Access Compliance Report

Public Rights-of-Way

(Curb Ramps)

Intersection ID: 13760	Main Street: EUCLID_AV	Cross Street: TEMPLETON_AV	Location:	N
ADA ID: E405AF8D3AA0	Ramp Type: Perp	Initial Pass/Fail: Pass	Overall Compliance: No	Severity Score: 0
Codes/Mitigation Info/Possible Solution		Field Measurements/Component Compliance

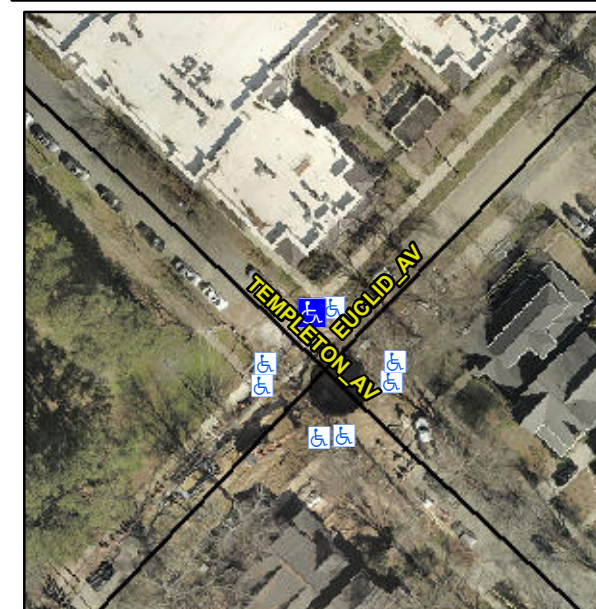
Remove & Replace Detectable Warning System. Gutter Ponding Observed.

R305.2, R302.7
